**TOWN OF DAVIDSON
PLANNING BOARD
Board Room
Davidson Town Hall
May 20, 2019**

Date: May 20, 2019
To: Planning Board Members
From: Jason Burdette, Planning Director
Re: Potts Street Residential Master Plan

POTTS ST RESIDENTIAL MASTER PLAN (LD# 376674)

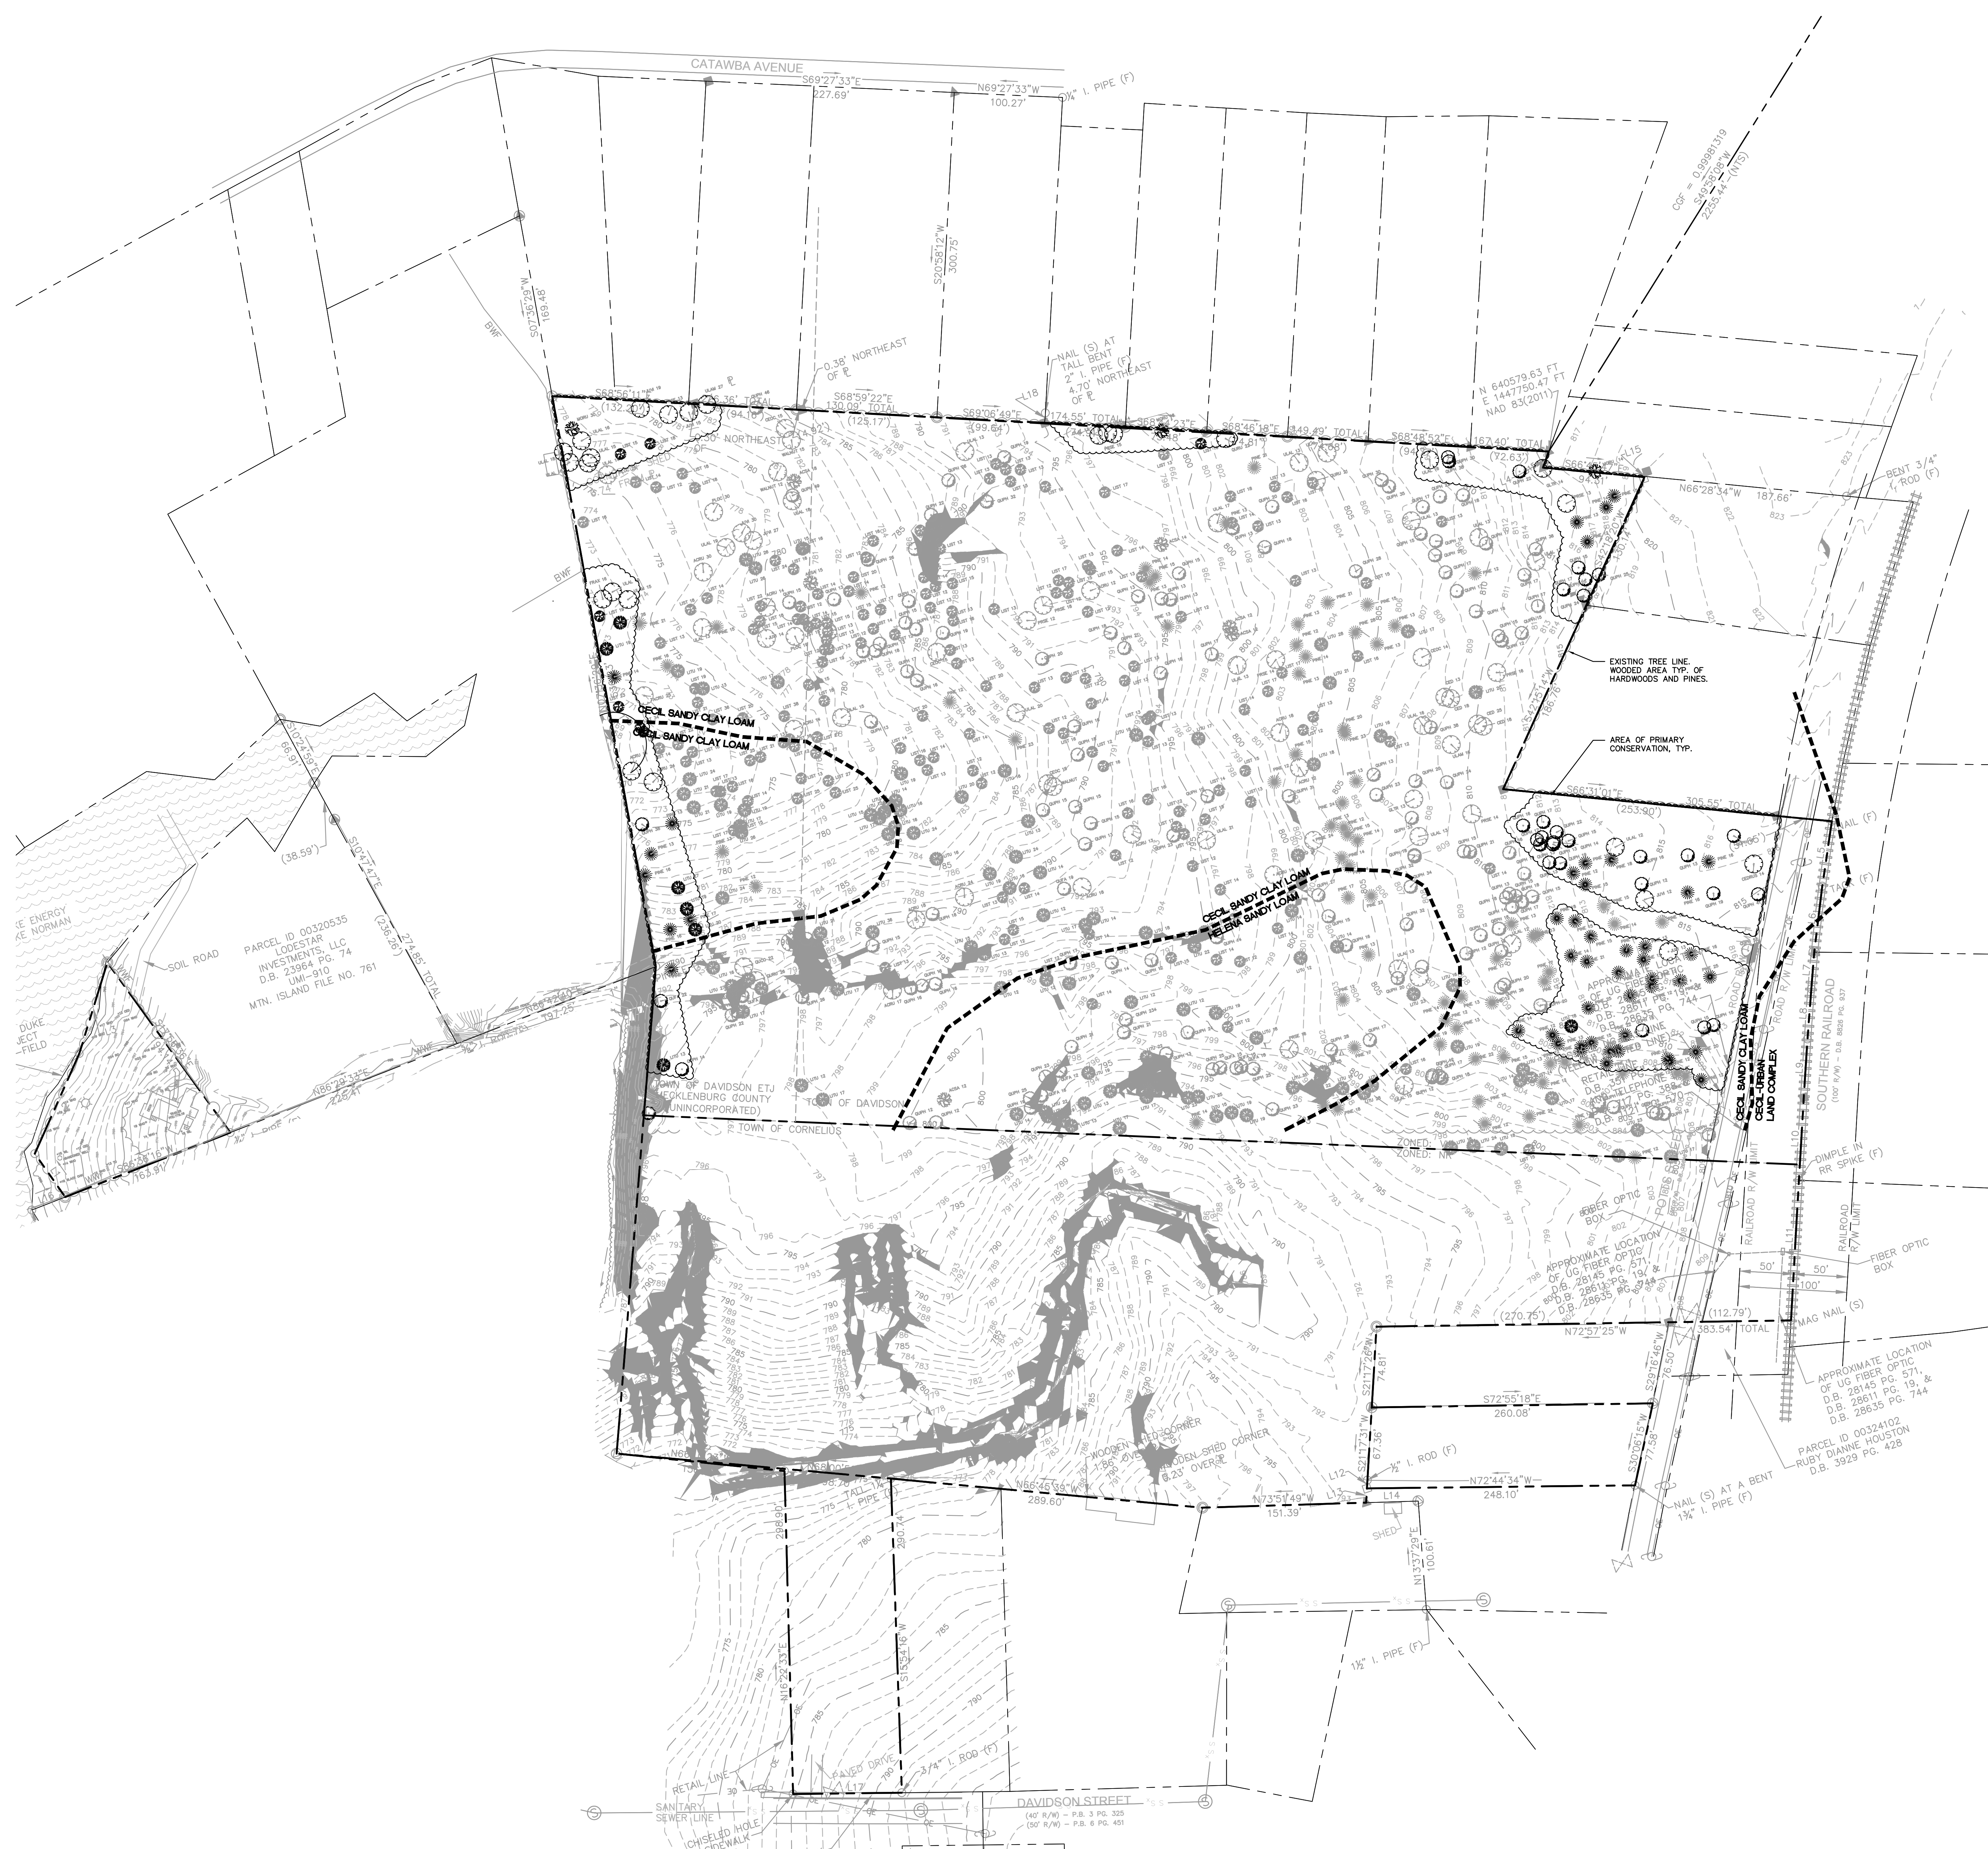
(Applicant has expressed the intent to build this greenway connection. Applicant shall provide written confirmation of the adjacent landowner's intent to provide the easement. Securing permission for an easement is a condition of the TIA approval).

C-003

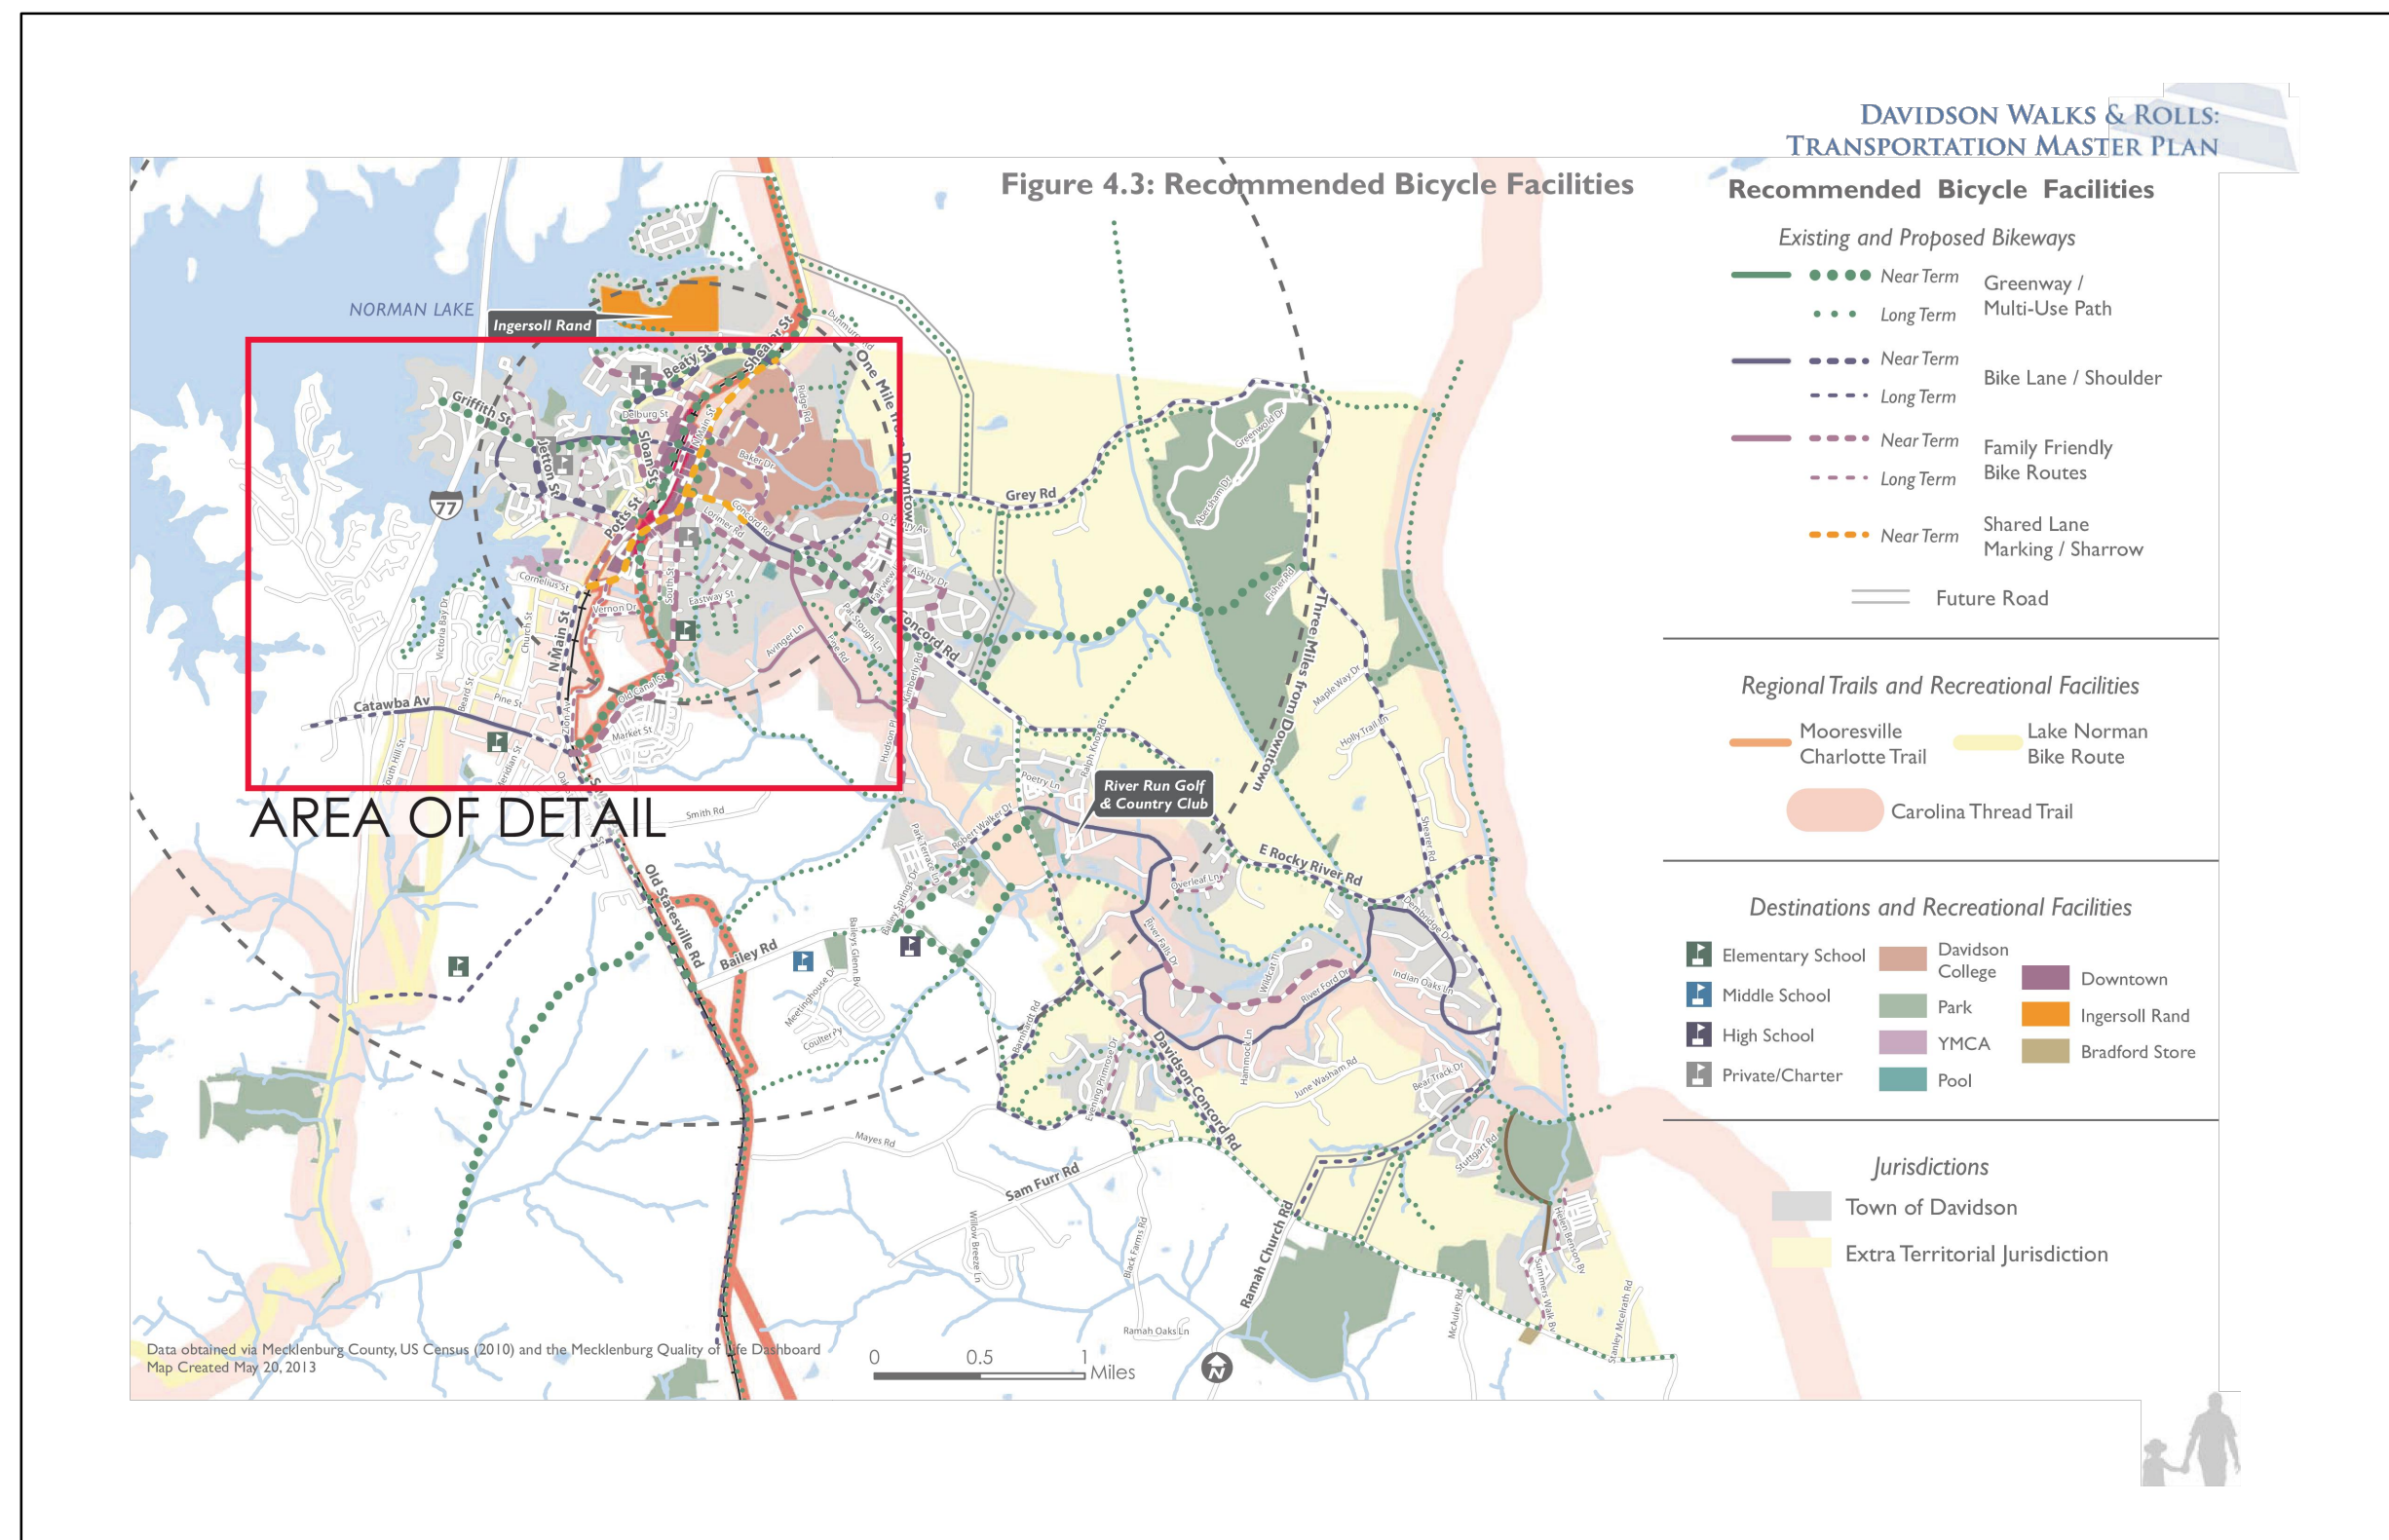
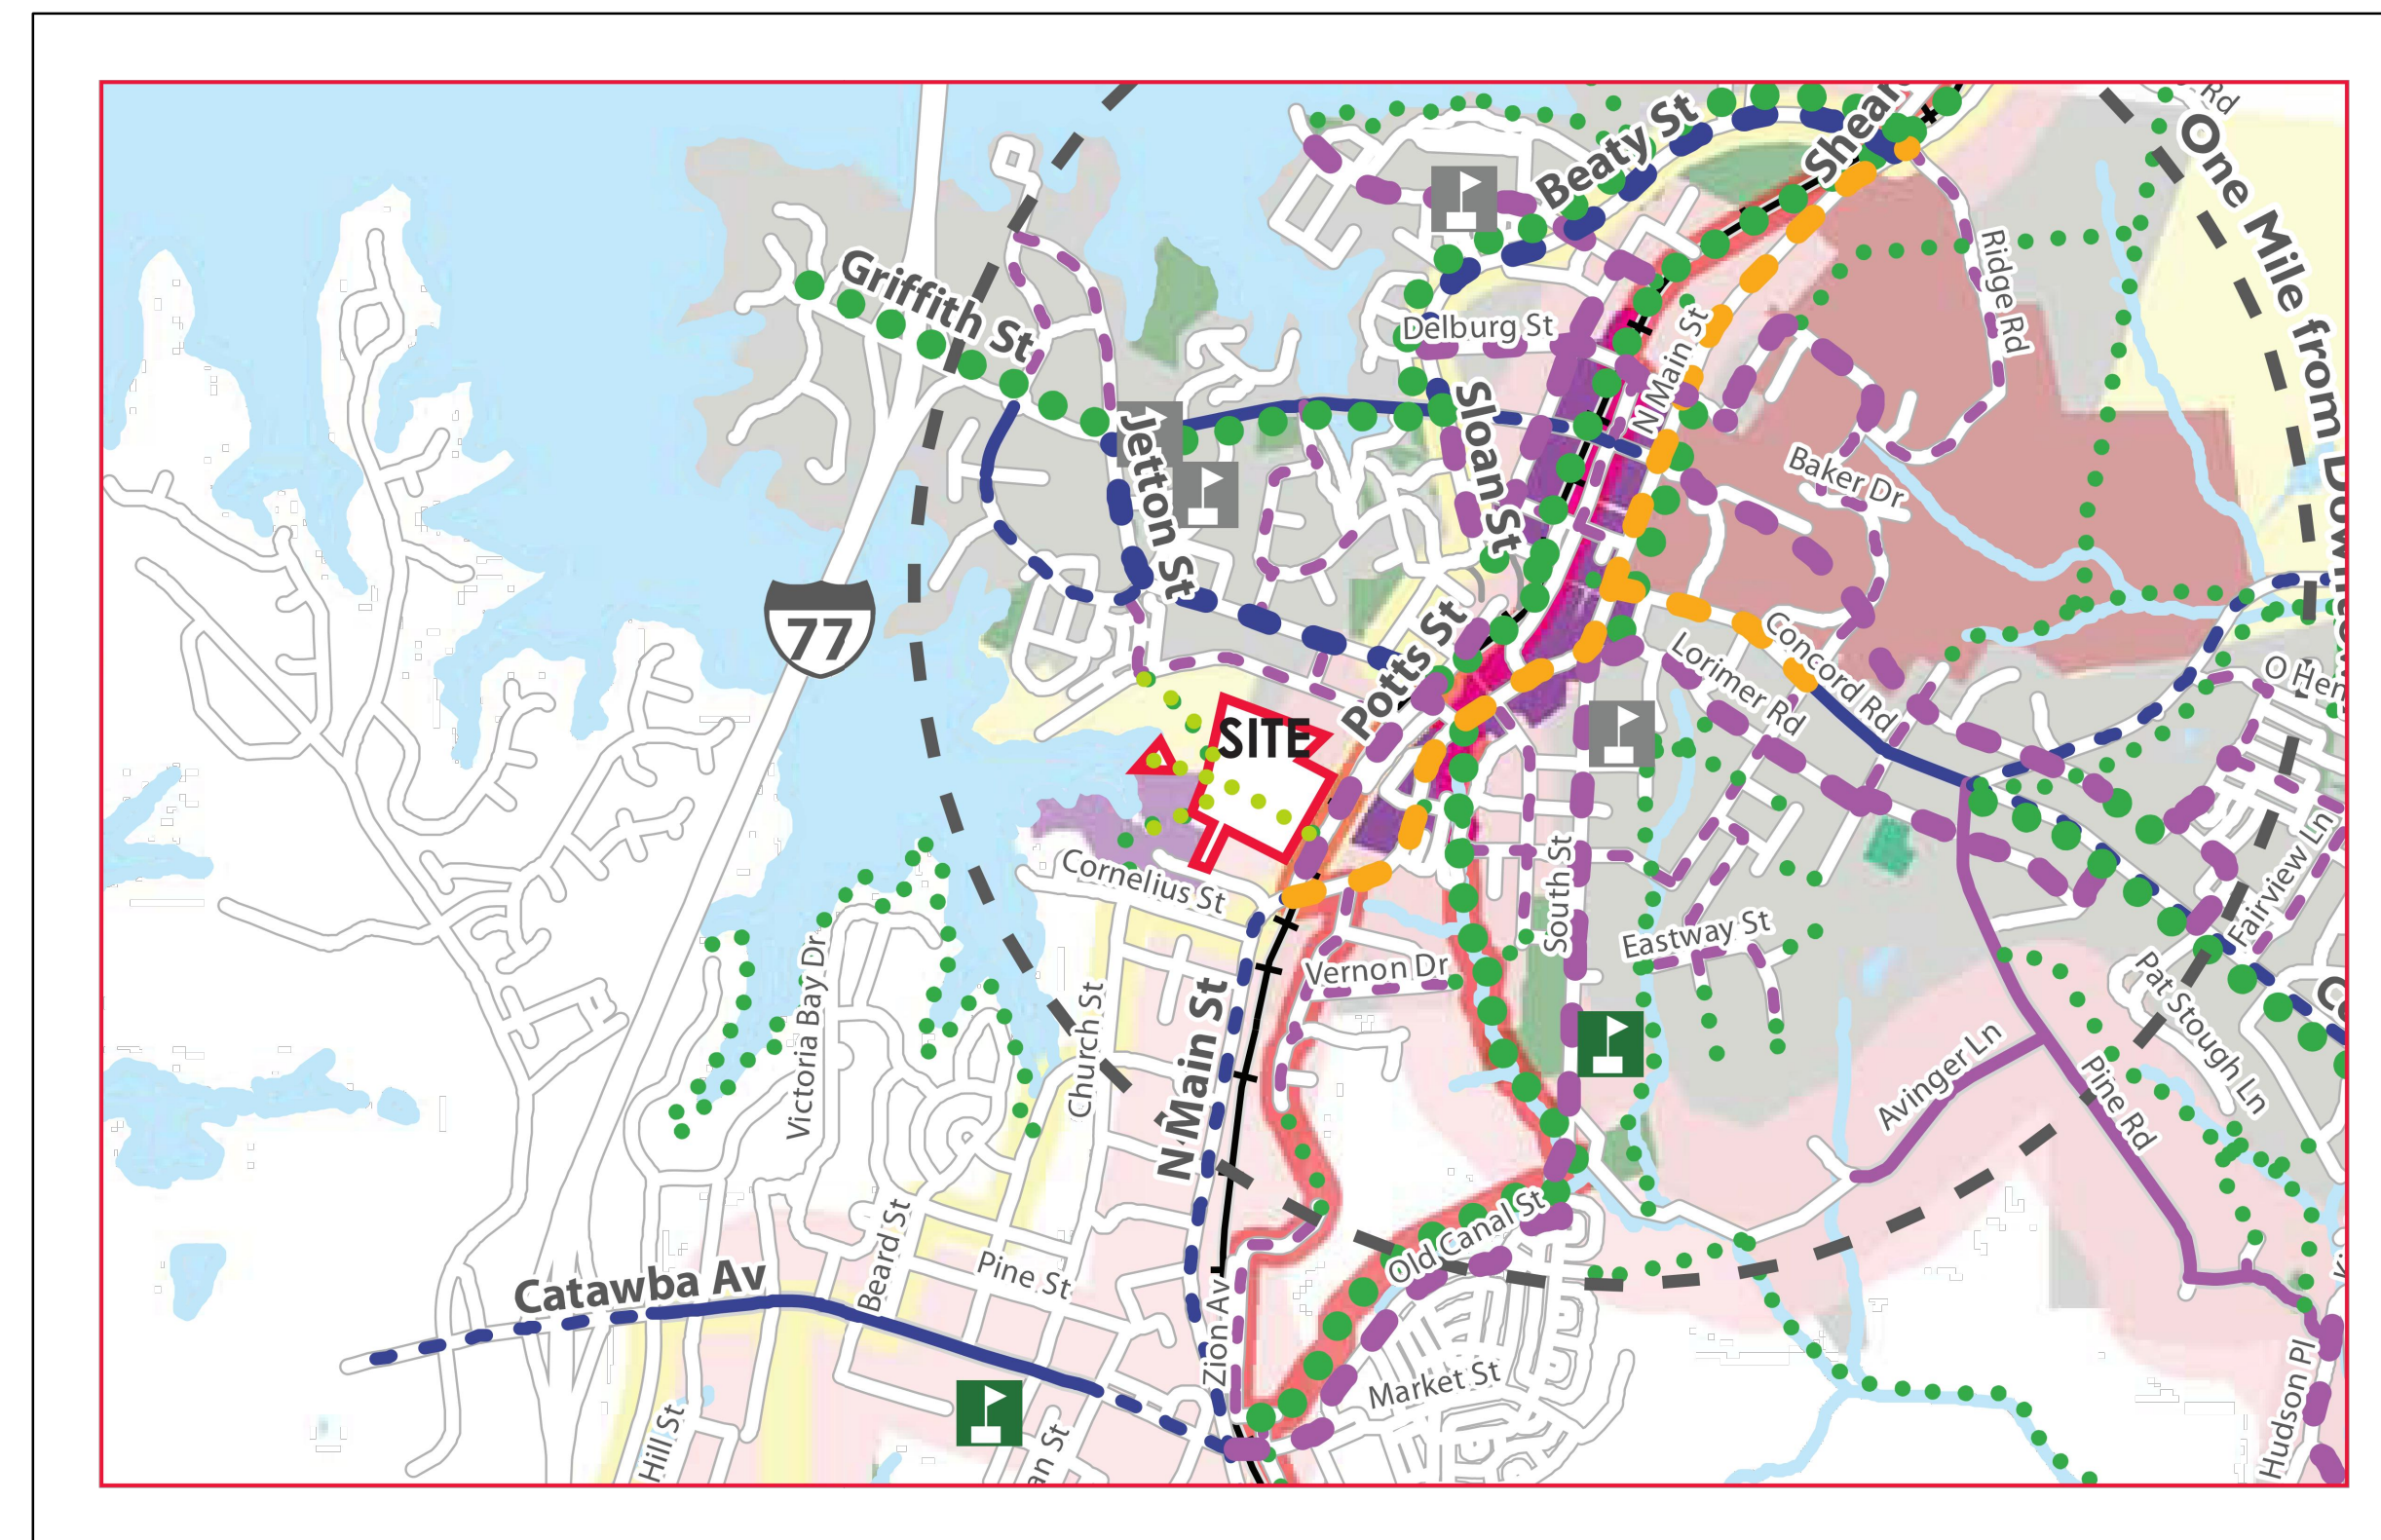
Ordinance, the project must provide undisturbed open space equal to at least 17.5 percent (2.62 acres) of the project area. Sheet C-003 illustrates these areas, which do not appear to be depicted consistently across all sheets including C-002 and C-004 (the latter possibly showing grading conflicts where designated open space is located on the west, north, and east sides of the main parcel). Nearly all of the proposed open space is shunted to the proposal's periphery as residual land area; it is not used as an organizing element as in many other Davidson neighborhoods.
